RAI Volume 2, Chapter 2.1.3, First Set, Number 1: Describe the process, including any procedures, which is used during the design phase to evaluate and select alternatives for design features that will facilitate permanent closure and decontamination, or decontamination and dismantlement.

RAI Volume 2, Chapter 2.1.3, First Set, Number 2: Describe the process used during the design phase to ensure that features that support waste minimization and worker safety are incorporated into the design and that ALARA principles are considered for decontamination and dismantlement activities.

Figure 1. Overview of Design and ALARA Processes

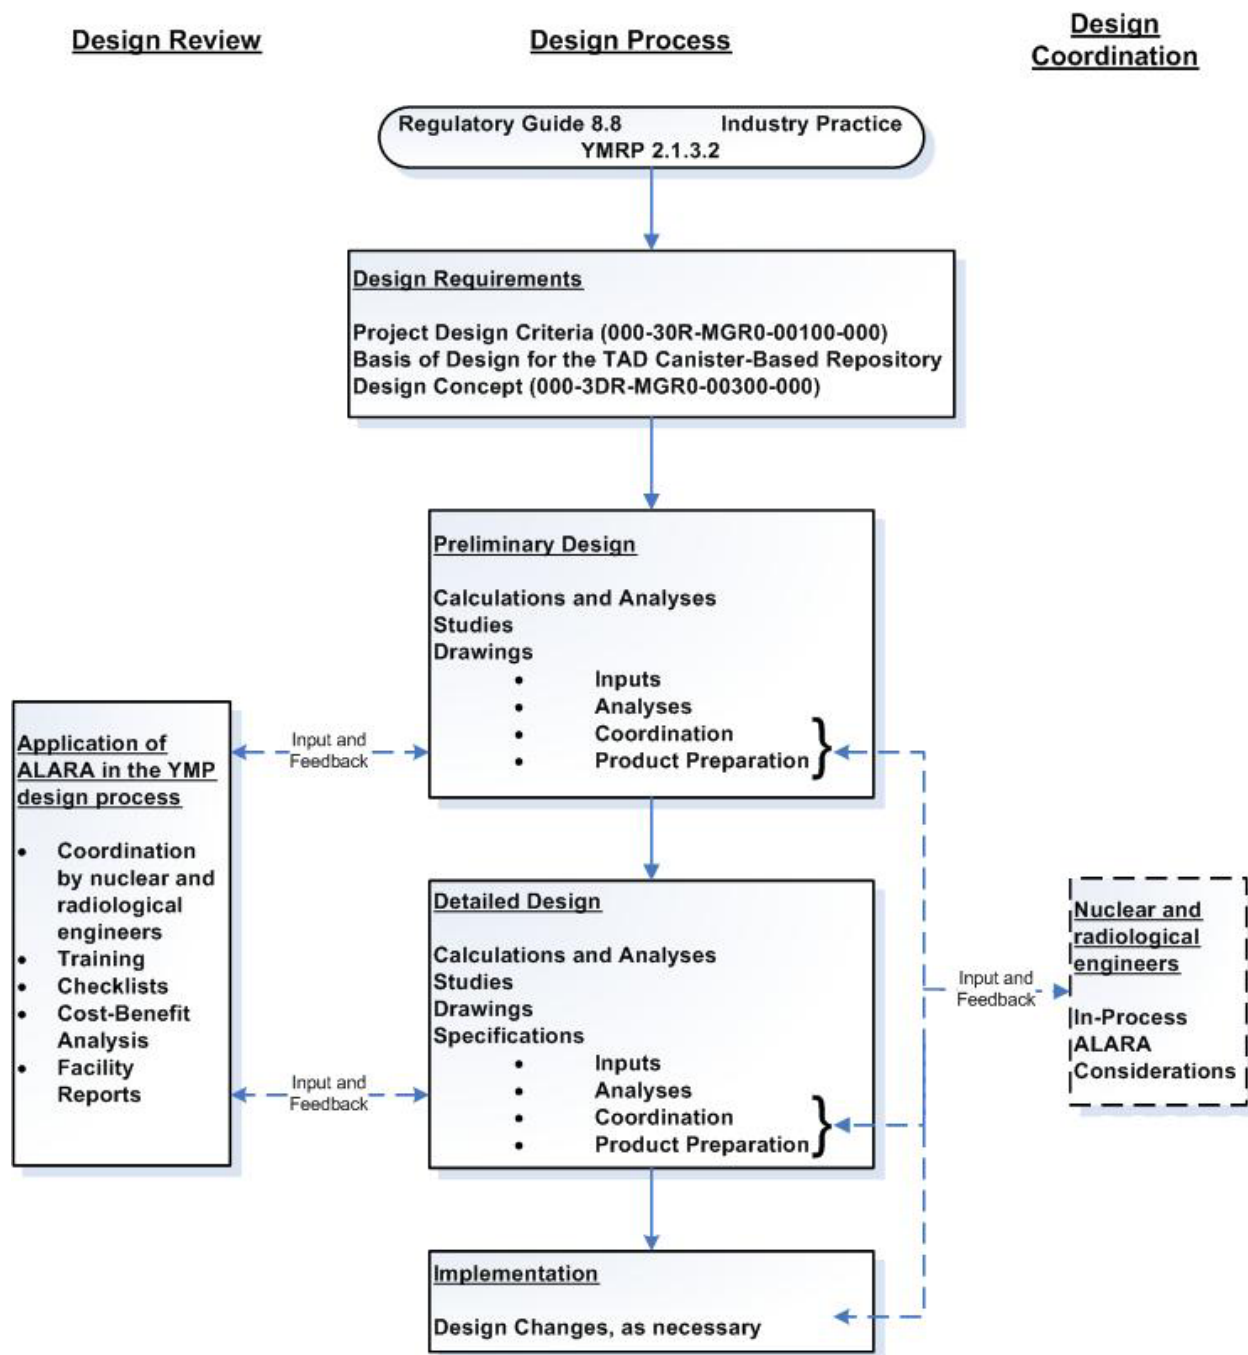
Section 1.12.1 of the SAR, described the requirements and criteria that will be applied in the design of the repository to facilitate permanent closure and decontamination, or decontamination and dismantlement. However, the applicant has not described the process for evaluating and selecting alternatives for appropriate design features. The applicant has not described how features that support waste minimization and worker safety are incorporated into the design and how ALARA principles are considered for decontamination and dismantlement activities. The staff needs the information to verify compliance with 10 CFR 63.21 (c) (8).

evaluate performance and functionality criteria, identify possible design alternatives, assess performance of the alternatives versus criteria and requirements, and select the optimal design alternative. This process of developing and evaluating design concepts and alternatives includes evaluation of the preclosure safety analysis, the use of procedural and desktop information checklists, design product checking, independent technical reviews, management reviews, ALARA reviews, and may be supported by value engineering studies and external independent reviews. Figure 1 provides an overview of the design process, including the ALARA reviews.
